CITY OF LA VISTA
MAYOR AND CITY COUNCIL REPORT
JANUARY 21, 2014 AGENDA

Subject:	Type:	Submitted By:
APPLICATION FOR REPLAT — JAYCEE PARK (SE OF HARVEST HILLS DR. & VALLEY VIEW DR.)	◆ RESOLUTION ORDINANCE RECEIVE/FILE	ANN BIRCH COMMUNITY DEVELOPMENT DIRECTOR

CASE NUMBER: 2013-SUB-06

RE: Application for Replat-Initial Review
Jaycee Park

**SARPY COUNTY
PRELIMINARY PLAT**

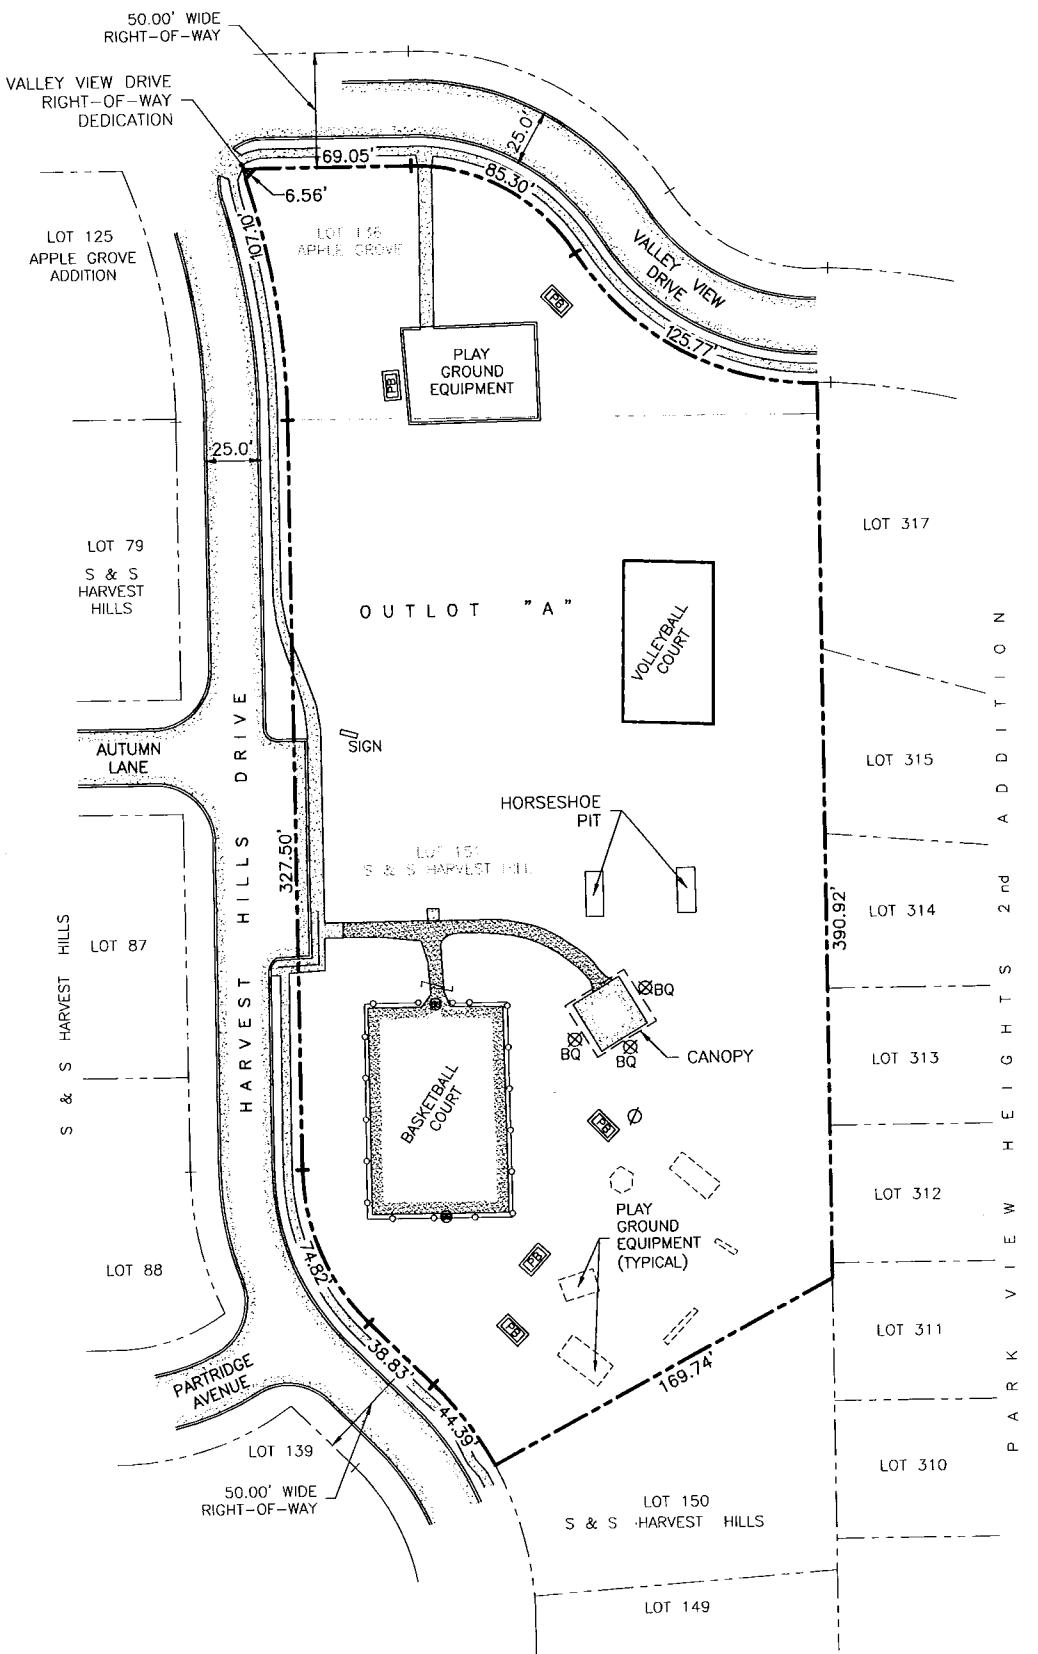
1. The requirements of Article 3.03 of the Subdivision Regulations have been met concerning content of a preliminary plat. There are various items that do not pertain due to the nature of the platting. These include erosion control plans, grading plans, subdivision agreement, etc.

4. The final plat was reviewed for compliance with Section 3.05 of the Subdivision Regulations. Various items are not applicable due to the nature of the replatting. There will be a need to request release of the side lot line easements along the common line between existing Lots 136 and 151. Releases from the affected utility companies need to be obtained by TD2 prior to the final plat mylars being recorded. I understand that utility companies are not processing such release requests until there is evidence of approval of the replat by the City. Therefore, the releases may not be available until after Planning Board and/or City Council approval.
